RE: ADDITIONAL INFORMATION REQUEST - 190 CROATIA AVENUE, EDMONDSON PARK

Reference is made to the Design Excellence Panel (DEP) meeting held on the 14th February 2018 regarding DA 265/2018. At the meeting, the panel members identified a number of suggested design amendments to the proposed development. Council has provided Urbis with the meeting minutes of the DEP meeting and this letter and attachments including amended architectural and landscape plans are the applicant's response to the matters discussed on the day.

Table 1 – Response to issues raised by the Design Excellence Panel

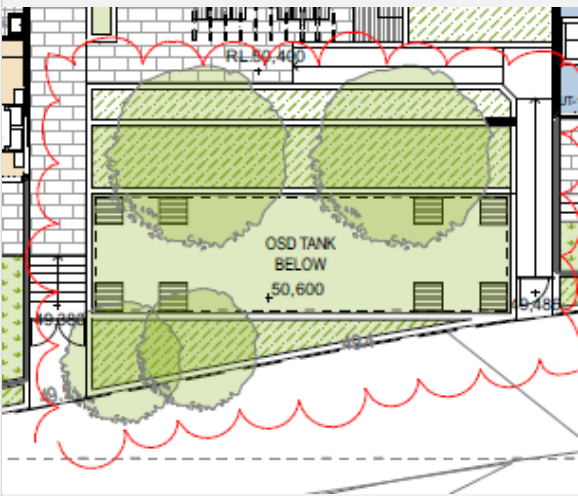
Item No.	Response	Recommendation Addressed
<p>façade and improve utilisation.</p> <p>Comment: The panel recommends redesigning the balconies, so that they work better, both spatially and visually. The long and narrow shaped balconies in the current design are not useable and provide limited articulation to the building facade. The panel recommends either redistributing the spaces within the apartments, in order to increase the size and shape of balconies or reducing the width of the balconies to create “outdoor spaces” rather than balconies, that are integrated with the internal spaces. This will break down the built form of the building</p>	<p>Figure 1. This amendment allows for better articulation of the facade and improves the visual amenity of the buildings when viewed from the adjoining streets. The design refinements create outdoor spaces as encouraged by the Panel, as shown in Figure 2 rather than long narrow continuous balconies as originally proposed.</p> <p>Figure 1 – Amended layout of balconies – Revision C</p>  <p>Figure 2 – Proposed balcony design – Revision B</p>  <p>The balconies on the corner of the larger units as shown in Figure 3, have been reduced to provide articulation and improve the built form. This addresses the Panel’s recommendation to reduce the visual bulk of the balconies when</p>

Item No.	Response	Recommendation Addressed
	<p>viewed from the street and the long continuous form of the balconies which is discouraged.</p> <p>Figure 3 – Reduction in balcony length</p>  <p>Similarly, as shown in Figure 4 balconies which were formerly wrap around balconies have now been further reduced as shown in Figure 5.</p>

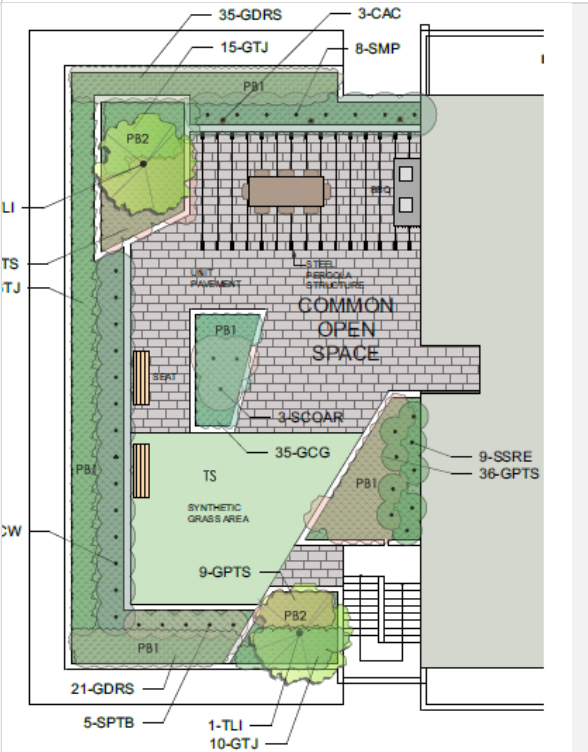
Item No.	Response	Recommendation Addressed
integrating panels into the building façade and/or covered shade areas on north of building/rooftop). This can be an attractive marketing feature for the development.	<p>Figure 6 – Proposed solar panels on rooftops of Buildings A, B and C.</p> 	
<p>Recommendation 2 –</p> <p>The panel recommends implementing different treatments on each different aspect of the building façade (e.g. different treatments to the north, south, east and west building facades).</p> <p>The panel commented that the scale and layout of the building promotes good solar access.</p>	<p>Recommendation 1 of Item 4.4 Sustainability has been addressed.</p> <p>The treatment to the façades for each of the Buildings A, B and C have been amended so that each elevation (eastern, western, northern and southern) of the buildings appear different. The revised elevations are shown on accompanying plans AP12 C – AP14 C Elevations. The amended plans also include changes to the finish of the proposed metal wall cladding material to a light grey finish to the address the Panel's comments and provide differentiation in colour tones of the material used.</p>	<p>Yes</p> <p>N/A</p>

Item No.	Response	Recommendation Addressed
	<p>The extent and nature of amendments to the balconies of the units in Buildings A, B and C are illustrated in the floor plans and elevations listed below:</p> <ul style="list-style-type: none"> • AP08 C – Level 1 • AP08 B -1 Level 2 and 3 • AP09 C- Level 4 • AP10 C- Level 5 • AP12 C- Elevations • AP13 C – Elevations • AP14 C – Elevations 	
<p>4.3 Density</p> <p>The panel commented that the layout and orientation of the proposal is working well.</p>	<p>No amendments are required, as the proposed layout and orientation of Buildings A, B and C is supported by the Panel and no further recommendations were made.</p>	N/A
<p>4.4 Sustainability</p> <p>Recommendation 1 -</p> <p>The panel recommends consideration of photovoltaic technology to generate power for lighting and electricity purposes in common areas (e.g. with LED lighting of car park and all common areas). This includes (if not implemented during initial building construction), future proofing the building to later incorporate photovoltaic panels (e.g. space for</p>	<p>In response to the Panel's recommendation to incorporate photovoltaic technology, the design has been amended to include solar panels to the rooftops of Buildings A, B and C as shown in Figure 6. The electricity produced will be used for the lighting of common areas including basement car parking areas.</p>	Yes

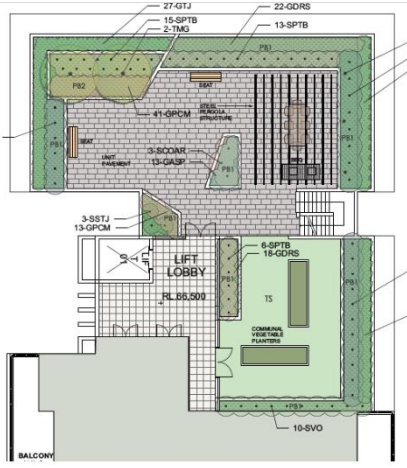
Item No.	Response	Recommendation Addressed
<p>Recommendation 1 – Deep soil zones</p> <p>The panel recommends that deep soil zones should be increased where possible to enable provision for planting of deep-rooted trees.</p>	<p>The site provides a total of 493.06sqm which equates to 11.38% of deep soil zones on the site as shown in Figure 7 . It should be noted that the proposed deep soil zone exceeds the 7% required under Section 3E of the Apartment Design Guidelines. The amended plans do not include additional deep soil zones within the site, however the landscape plans have been amended to incorporate additional tree and shrub plantings</p> <p>Figure 7 – Proposed deep soil zones</p>  <p>The design refinements have resulted in a redesign of the OSD tank which has enabled the planting of two large and two medium sized trees facing Croatia Avenue as shown in Figure 8.</p>

Item No.	Response	Recommendation Addressed
<p>Recommendation 2 –</p> <p>The panel recommends encouraging richness of the building through the landscape, which can be achieved through pushing the landscape</p>	<p>Figure 8 – New trees proposed south of Building B near OSD tank facing Croatia Avenue.</p>  <p>In addition to this, the amended design provides additional trees facing Costello Lane (Building B) including one large and three medium sized trees as shown in Figure 9.</p> <p>Figure 9 – Proposed trees facing Costello Lane</p> 	<p>Yes</p>

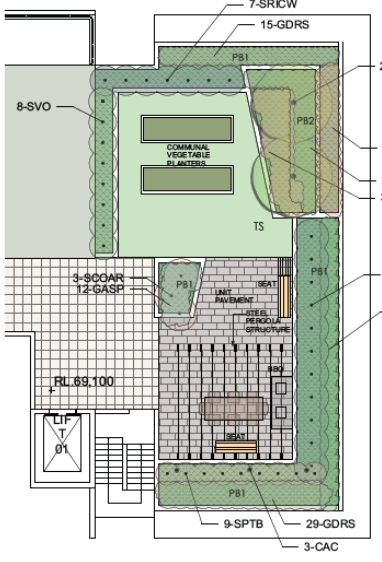
Item No.	Response	Recommendation Addressed
<p>design further, in order to maximise its value. The panel recommends including large trees wherever possible, for shade and selecting drought resistant native species (including grasses) that are suited to the local climate in Liverpool.</p> <p>Recommendation 3</p> <p>The panel recommends considering the use of artificial turf, which may be appropriate in certain areas within the site, such as heavily trafficked areas/rooftops (i.e. there are water permeable and resilient options now available).</p>	<p>The amended landscape proposal provides an additional eight trees on the site and addresses recommendation 1 of Item 4.5 Landscape.</p> <p>The landscaped plan has been amended based on the recommendations of the Panel to include large trees into the design (where possible). These trees are visible from the roads and will soften the built form as shown in Figure 9 whilst providing shade to common open spaces as shown in Figure 8. The amended landscape design addresses recommendation 2.</p> <p>At the recommendation of the Panel, artificial turf has been incorporated into the communal open space areas which were proposed to have natural turf installed. The artificial turf proposed to the communal open spaces for Level 4 of Buildings C and A are shown in pictures 1 and 2 of Figure 10.</p>	<p>Yes</p>
